Errata Sheet for PIC16C62B/72A

The PIC16C62B/72A (Rev. A) parts you have received conform functionally to the PIC16C62B/72A data sheet, (DS35008A), except for the anomalies described below.

Clarifications/Corrections to the Data Sheet:

Figure 20-1: PIC16CXXX Voltage-Frequency Graph

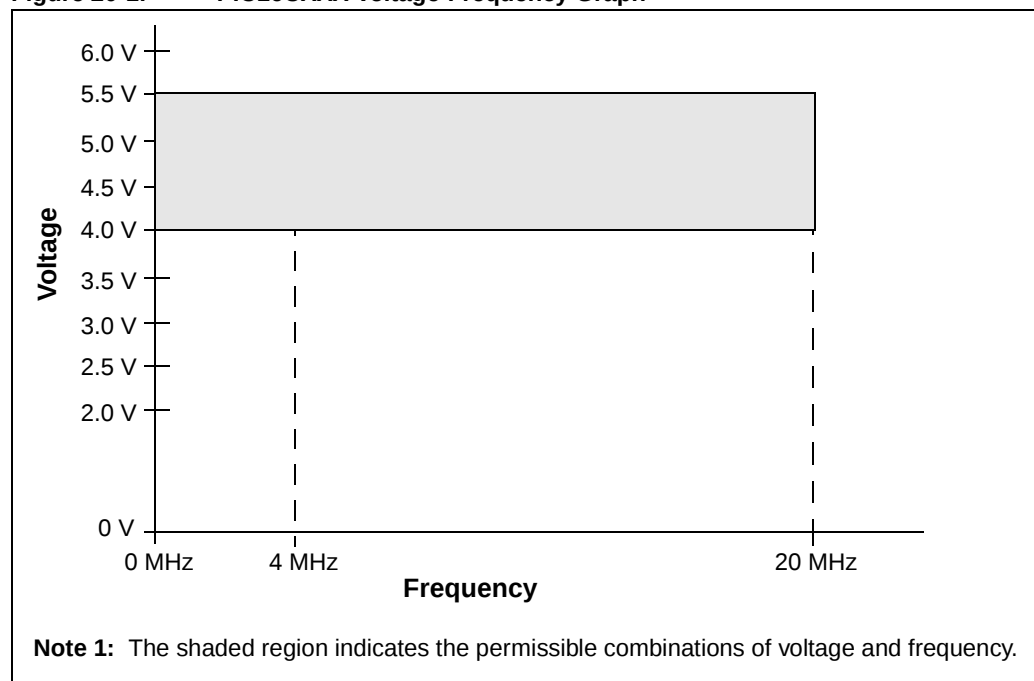
Figure 20-1 and Figure 20-2 are additions to the data sheet to show the area of operation. These figures replace the Cross Reference of Device Specs for Oscillator Modes Table in the Electrical Specification section.

Figure 20-1 shows the voltage vs. frequency operation for the PIC16CXXX devices. Devices marked with a "-04" operate up to 4 MHz, while devices marked with a "-20" operate up to 20 MHz. The entire shaded region is the valid operating region.

Figure 20-2: PIC16LCXXX Voltage-Frequency Graph

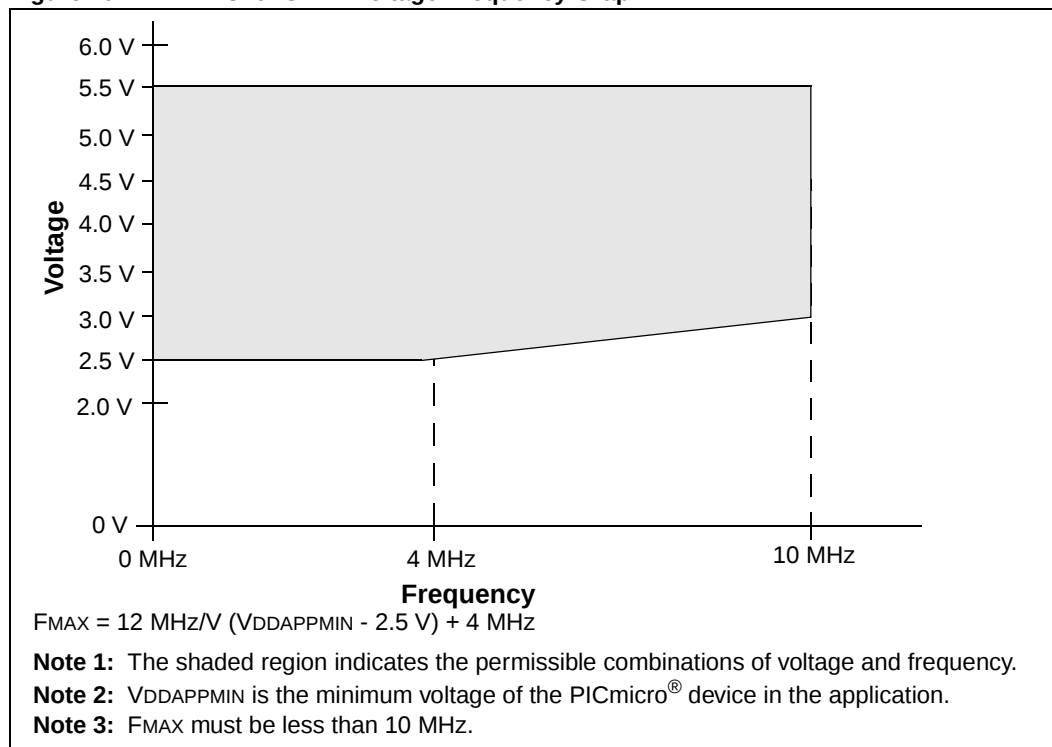
Figure 20-2 shows the voltage vs. frequency operation for the PIC16LCXXX devices. The devices marked with a "-04" operate up to 4 MHz at the minimum supplied voltage. The devices also operate at a higher frequency (10 MHz) and at a higher voltage (3V). The entire shaded region is the valid operating region.
